**RE:** 1305 7<sup>th</sup> St. NW

Grading and Drainage Plan Engineer's Stamp Date: 02/17/23

Hydrology File: J14D204

Based upon the information provided in your submittal received 02/17/2023, the Grading & Drainage Plan is approved for Grading Permit (earthwork can get started for the earth pad on the house).

C1 JOB#

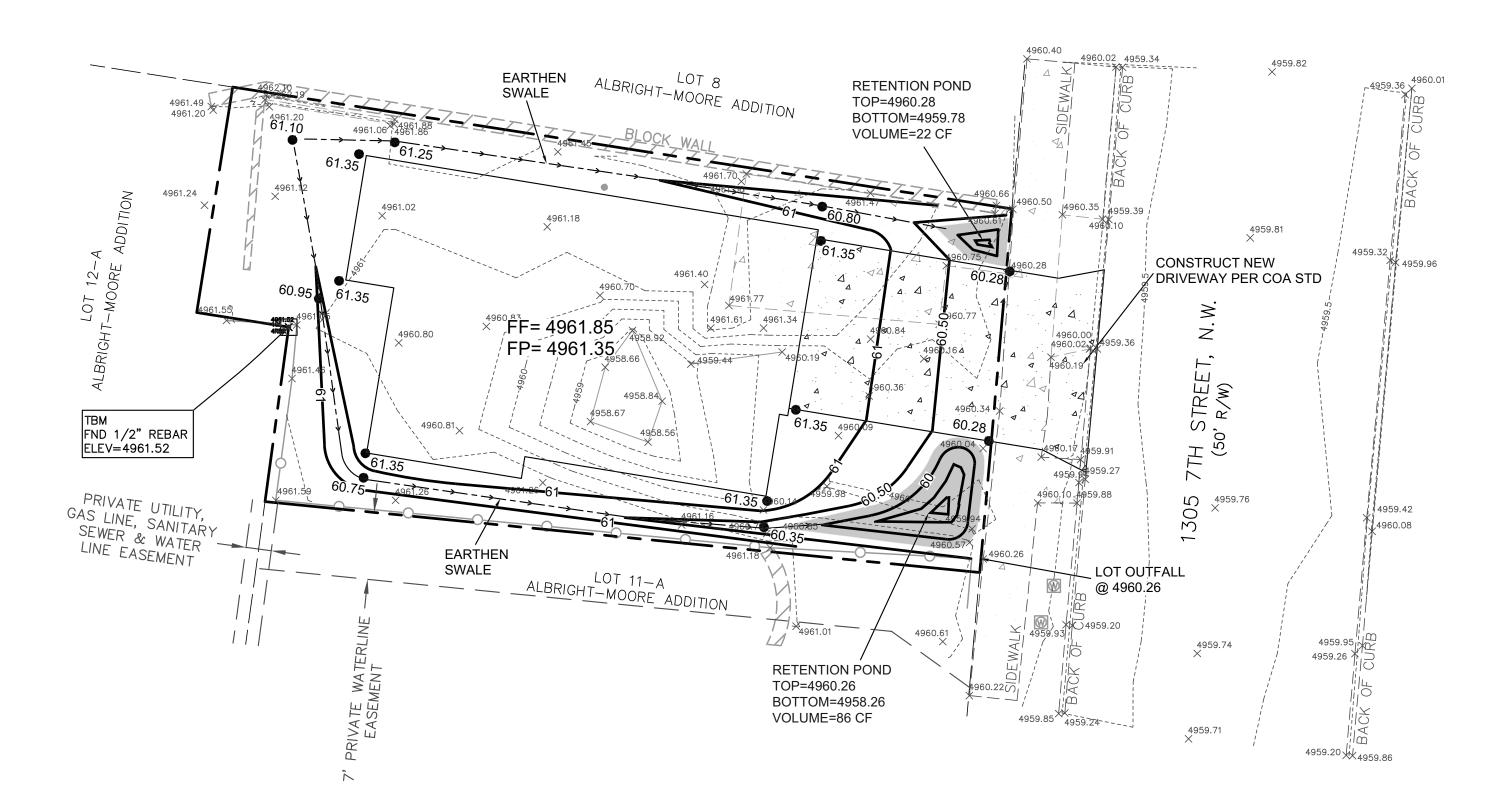
1. Once the grading is complete, a pad certification (meaning that the earthwork is

complete) will be required. Please include a site photo with the submittal. Also, at the time of pad certification approval, Hydrology will concurrently approve the Grading & Drainage Plan for Building Permit.
